# Product Change Notification

Product Group: OPT/Thu May 11, 2023/PCN-OPT-1275-2023-REV-0

## TSHF5210, TSHF6210, TSHF5410, TSHF6410 - Change in Chip

Page 3 of datasheet – Graphs

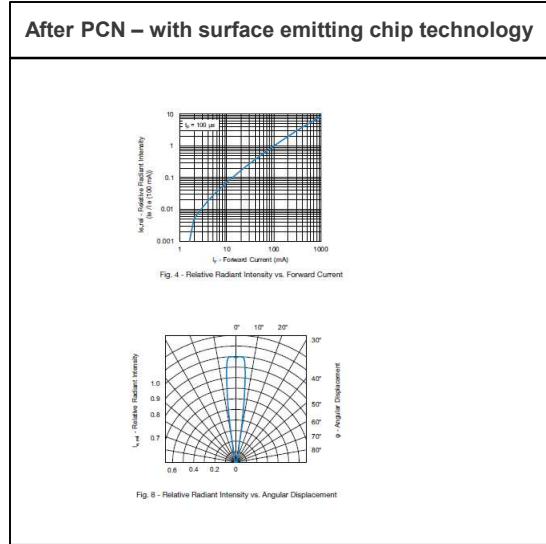
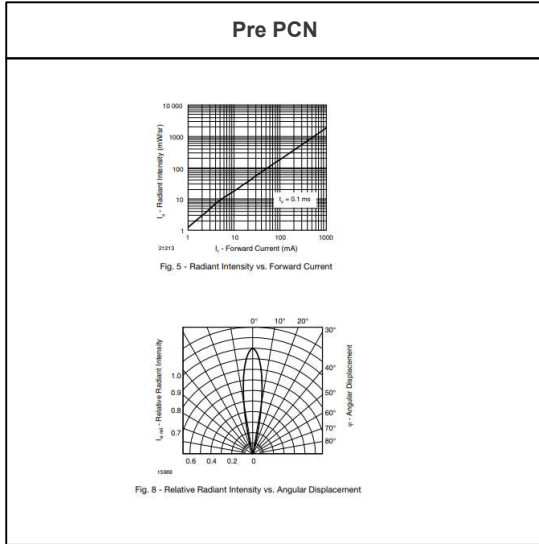
- Slightly smaller angle of half intensity
- Same radiant power
- Higher radiant intensity
- Higher forward voltage
- No change in package dimensions
